## Comments on Changes to the Requirements for Warning Signal Generation Associated with Excessive Coupling Force Control as Proposed by Denmark in ECE/TRANS/WP29/GRRF/2012/12

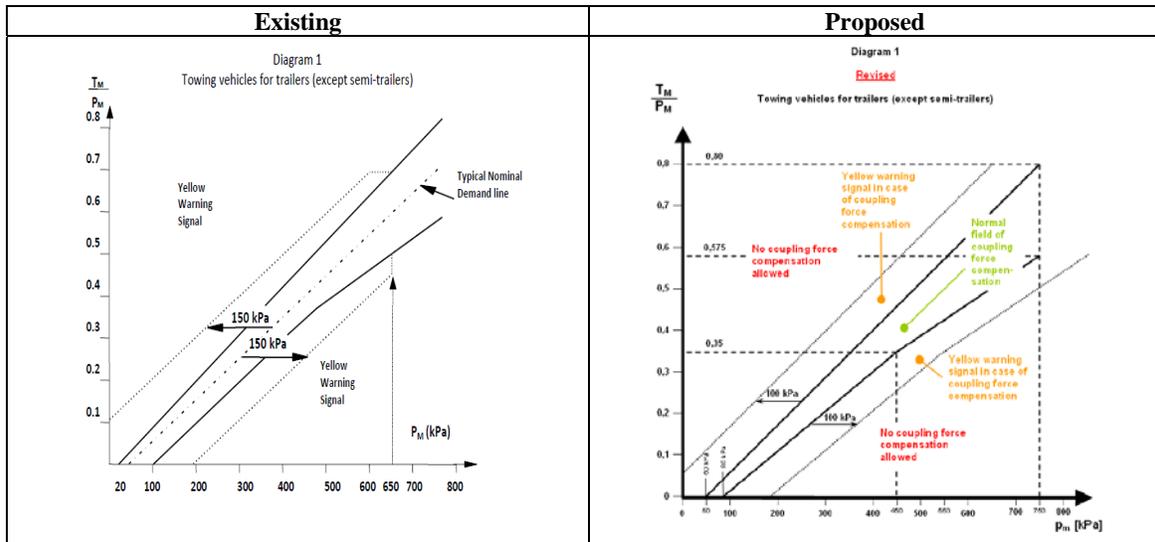
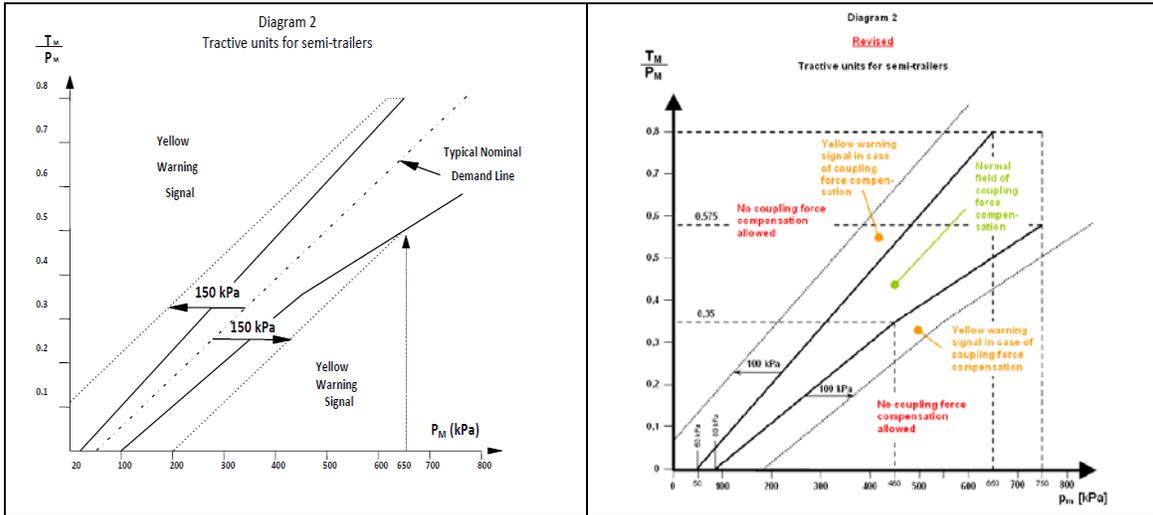
Currently the driver warning signal is not generated until the coupling force control function adjusts the braking performance of the towing vehicle by +/- 150kPa from the “nominal demand line” which is the design braking performance of the towing vehicle relative to coupling head pressure. The proposal from Denmark is to significantly reduce the amount of compensation that may be applied before a driver warning signal is generated.

It is well documented that the majority of brake applications on heavy commercial vehicles are within the coupling head pressure range up to 200kPa. Therefore if the design braking performance was such as to be in the centre of the compatibility band at a coupling head pressure of 200kPa the amount of coupling force control adjustment permitted before a driver warning signal is generated would be +/- 30kPa which in real terms means a reduction of 80% (150kPa to 30kPa). At brake demands below a coupling head pressure of 200kPa the pressure differential before generation of the warning signal would gradually reduce to a minimum value of 15kPa, equivalent to a 90% reduction in the tolerance. Equally should the “nominal demand line” approach either the upper or lower lines of the compatibility band the tolerance when a warning for excessive coupling force control being applied could reduce to zero.

In consequence it is considered by CLEPA, OICA and CLCCR experts that the proposal from Denmark would have a detrimental impact on braking compatibility. In consequence it is recommended that the requirements for coupling force control as currently specified within ECE Regulation 13 should remain unchanged.
